**MONTGOMERY COUNTY PLANNING DEPARTMENT**  
 THE MARYLAND-NATIONAL CAPITAL PARK AND PLANNING COMMISSION

**MEMORANDUM**

**PROJECT:** Goshen Road from 650 feet south of Girard Street  
 to 1,000 feet north of Warfield Road  
 CIP No. 509337

**REVIEW TYPE:** Mandatory Referral No. MR2009805

## GOSHEN ROAD NORMAL TYPICAL SECTION

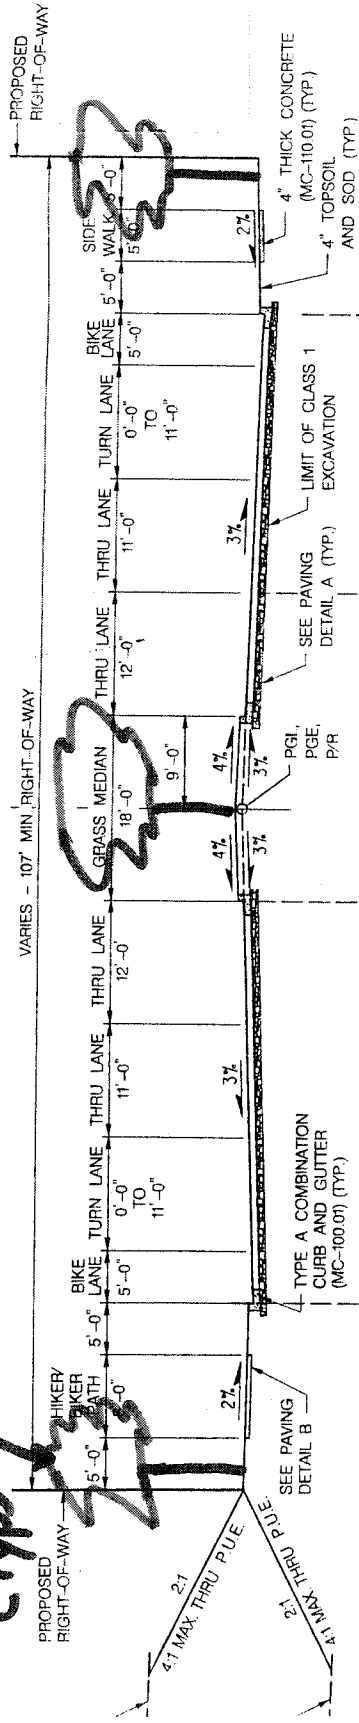
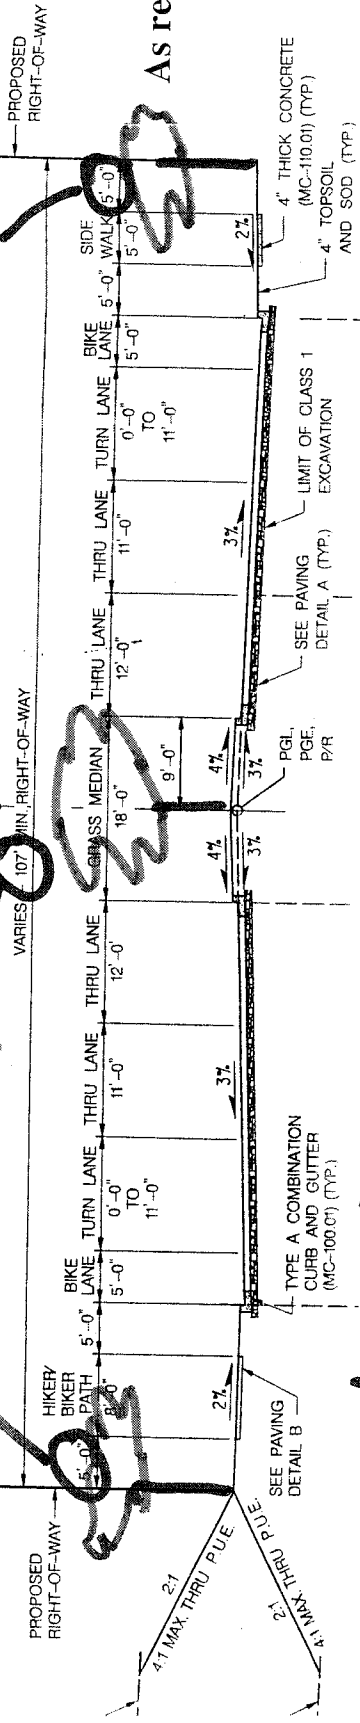
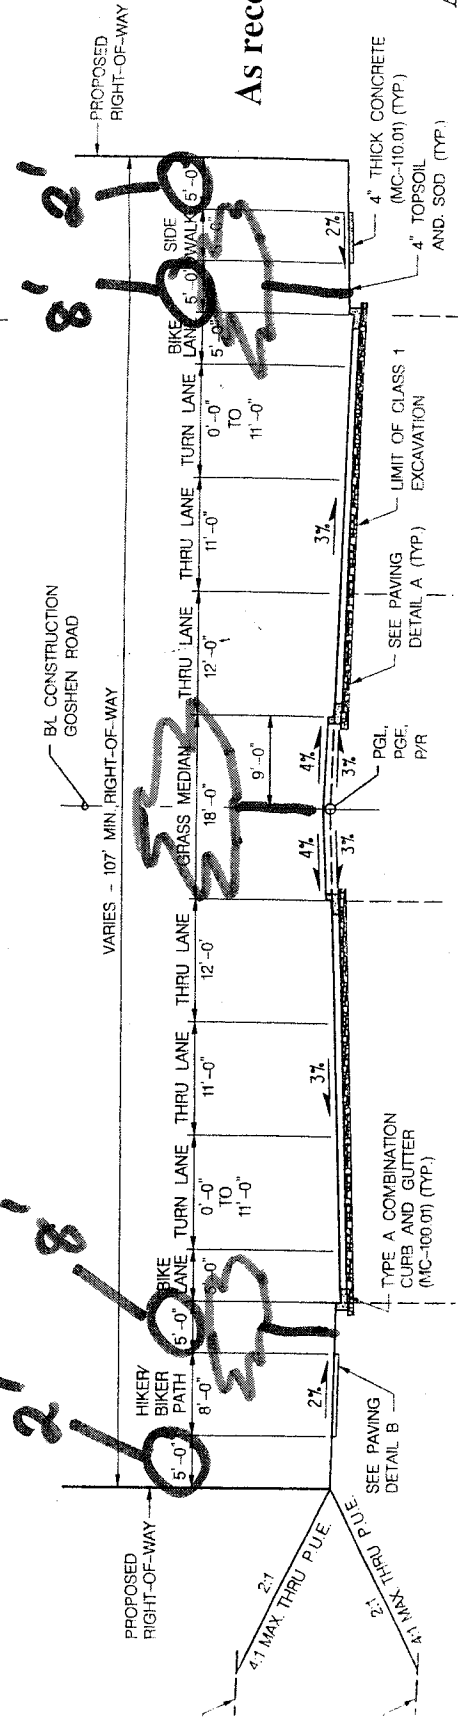
The proposed project would provide street trees along both sides Goshen Road as well as in the eighteen-foot-wide median. We recommend that the street trees should be 2-1/2"-3" cal. planted at fifty feet on center, Japanese Sephora in the median and Japanese Zelkova in the landscape panels between the curb and sidewalk. We recommend that street trees be planted also along intersecting streets within the limits of work.

MCDOT has agreed to plant the recommended trees in the median but has not agreed to plant street trees between the curb and sidewalk/shared use path. The typical section for Goshen Road is 107 feet wide, less than the 120 feet recommended in the Gaithersburg Vicinity Master Plan. Even so, the typical section shown in the plans could be adjusted to provide sufficient space for street trees by shifting the curb and sidewalk/path three feet to meet the 10-foot minimum offset between the center of the tree and the travel lane that is required for 40 mph roads per the new Tree Standard. MCDOT has met with two neighborhood groups who have concerns about the impact of the project, and MCDOT has agreed to reduce the width of the typical section further to 103 feet, which would make it impossible to get street trees in their normal location and still meet the new standard (see Attachment 4).

1. Reduce the width of the travel lanes adjacent to the median to 11.5 feet and increase the width of the bike lanes to 5.5 feet to be more consistent with the County's new road standards.
2. Curb radii should be reduced to thirty feet wherever possible but should not be greater than fifty feet.

17. Plant 2-1/2"-3" cal. street trees along Goshen Road at fifty feet on center, Japanese Sephora in the median and Japanese Zelkova in the landscape panels between the curb and sidewalk/path. Adjust the typical section to increase the panel width to provide a sufficient clear zone where possible.
18. Provide a consistent landscaping treatment behind the sidewalk/path at major intersections to reflect their status as gateways to communities.
19. Plant street trees along intersecting streets within the limits of work.
20. Use an ashlar slate pattern for concrete medians.
